Submission seeking ministerial review of Water Controller’s decision to grant the new water extraction licence WDPCC10000 to Fortune Agribusiness

A. INTRODUCTION

ANNEXURE A - MAPS

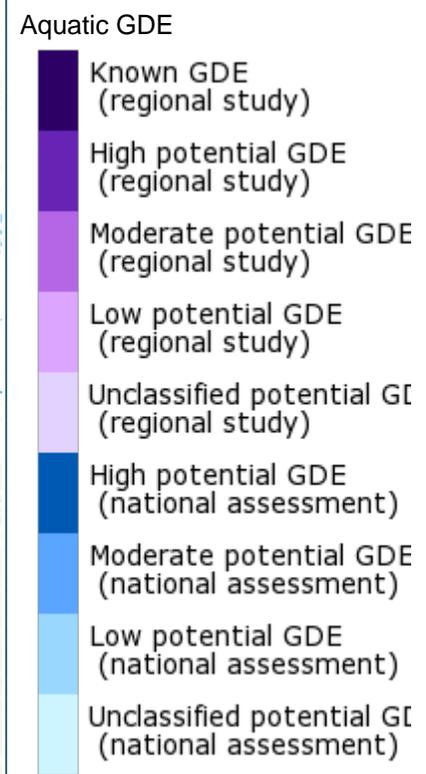
51. There is a major gap in the allocation planning and impact assessment in the WDWAP as aquatic GDEs have not been included.
52. According to the attached maps in Annexure A, which are extracted from the Bureau of Metrology GDE atlas, there are numerous sites with potential to contain aquatic GDEs. Given the proximity of these sites to Singleton Station, there is a possibility of the sites being impacted by the Singleton Water Licence.

53. Aquatic GDEs, particularly wetlands, springs and soakages, are typically those with the greatest sensitivity to drawdown. These are often the sites of greatest biodiversity and highest cultural value. The Fortune Report, which is a report considered by the Water Controller⁴⁷, fails to assess the impact of Singleton Water Licence on aquatic GDEs. The Guideline fails to contain any criteria for aquatic GDEs. The Water Controller also fails to consider the impact of the Singleton Water Licence on aquatic GDEs in the Western Davenport District in making the Water Controller Decision.

54. Aquatic GDEs are much more sensitive to drawdown than terrestrial vegetation GDEs, and the drawdown criteria proposed for the GDEs do not incorporate the more stringent drawdown criteria appropriate for aquatic GDEs. In some cases, any change in groundwater levels can “detach” the water table from these aquatic GDEs which will have serious impacts to aquatic fauna in particular. This could cause species to become locally or even regionally extinct. Rare and endangered species may be utilising these systems for resources and/or habitat but this has not been assessed.

The sites identified in the maps in Annexure A should be selected at a minimum for biological, hydrological and hydrogeological investigation and other aquatic sites, particularly culturally significant aquatic sites, should also be included. Aquatic GDEs need to be surveyed for:

These surveys need to be linked to cultural value studies. Once completed, a relative biodiversity and cultural value ranking assessment can be carried out and hydro-ecological linkages and degree of groundwater dependence determined. This will provide the requisite understanding of the ecological thresholds and EWRs required to manage these important sites.
